Units 1, 2, and 3 Docket Nos. STN 50-528(License No. NPF-34)/529/530 License Condition 2.C.6(c) and 2.C.18(c) File: 85-056-026; G.1.01.10

Attached is a proposed FSAR change for FSAR Figure 9.4-9. ANPP has re-evaluated the need to have Quality Class "Q" temperature elements for the charcoal filters of the fuel building essential air handling units. These temperature elements provide the operators with an indication of when the charcoal filters are approaching their desorption temperature for radioactive iodine. ANPP has previously determined that there are no ESF filter units at PVNGS that will exceed 200° F following a postulated DBA as a result of a loss of air flow (refer to FSAR Section 1.8, Regulatory Guide 1.52, Position C.3.K). The concern of ANSI/ASME N509-1976 is that desorption of iodine may occur at elevated temperatures (e.g., >300°F). Therefore, the desorption temperature will not be reached in the charcoal filters of the fuel building essential air handling units and there is no need to have temperature elements to monitor the charcoal bed temperature. For these reasons, the quality classifications for the four temperature elements have been downgraded from Quality Cl

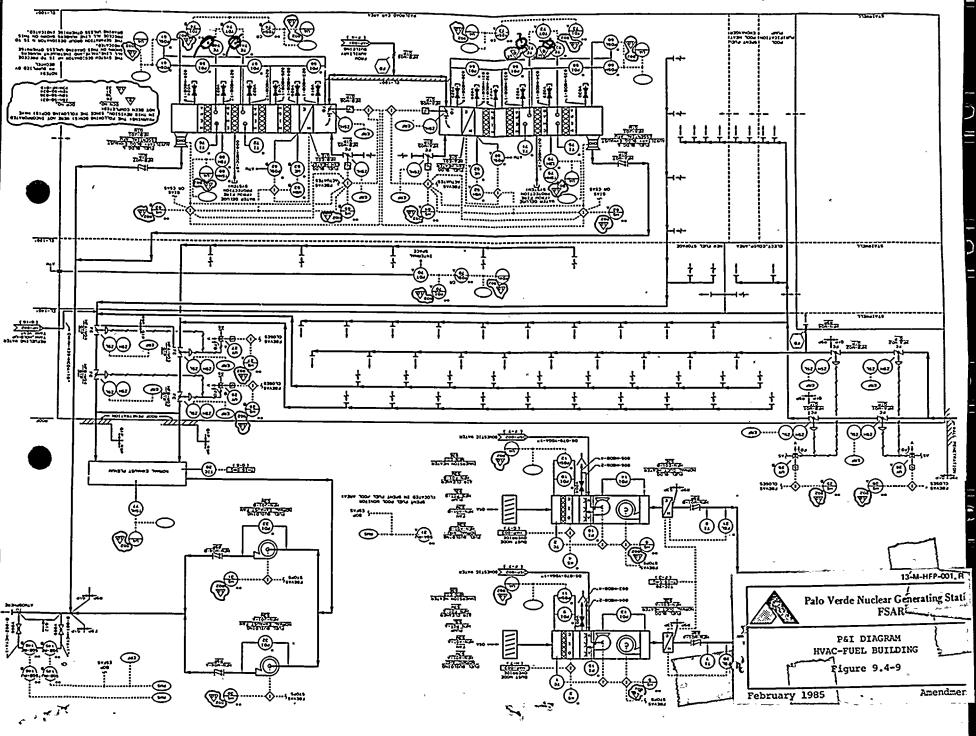
Reference (1) submitted a Justification for Interim Operation (JIO) for PVNGS Unit 1 in order to complete the seismic qualification of these four temperature elements which are located adjacent to the charcoal filters of the fuel building essential air handling units. Additionally, Reference (2) submitted a JIO in order to complete the environmental qualification of these same four temperature elements. These JIO's are discussed in Sections 3.10 and 3.11 of Reference (3) and the staff has imposed License Condition 2.C.6(c) and 2.C.18(c) for the temperature elements to be seismically and environmentally qualified prior to PVNGS Unit 1 initial criticality. The JIO's of References (1) and (2) stated that the function of these temperature elements is to alert the control room operator of potential filter fires. This stated function was in error. The actual function of the temperature elements is to provide the operators with an indication of when the charcoal filters

are approaching their desorption temperature for radioactive iodine. Since it has been determined that non-Quality Class "Q" equipment is acceptable for use in this application, the temperature elements have been removed from the scope of the Equipment Qualification Program. These temperature elements are considered to be fully qualified for their application at PVNGS.
